**City of Portland, Maine – Building or Use Permit Application** 389 Congress Street, 04101, Tel: (207) 874-8703, FAX: 874-8716

| Proposed Project Description:<br><br>Install Above Ground Round 24 x 52 Pool |  |  |  | PEDESTRIAN ACTIVITIES DISTRICT (P.A.D.)   |  |                                      |

BUILDING PERMIT REPORT

REASON FOR PERMIT: To Install Above Ground Round 24' x 52" Pool

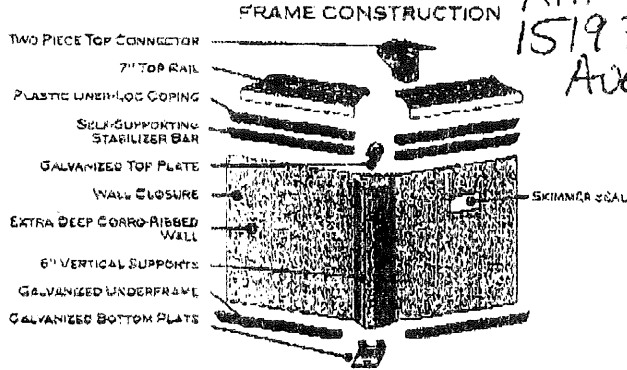
- 5-16-00 Checked proposed setbacks — Moved location of to house referencing the Bay window projection — not the area marked from the flat house wall. Left my card with note of location change — All other setbacks good. Will need electrical inspection of existing outside receptacle. JB

All pools are required to be  
 10' from rear and side lot lines  
 Also shall be 10' from principal  
 structure - S
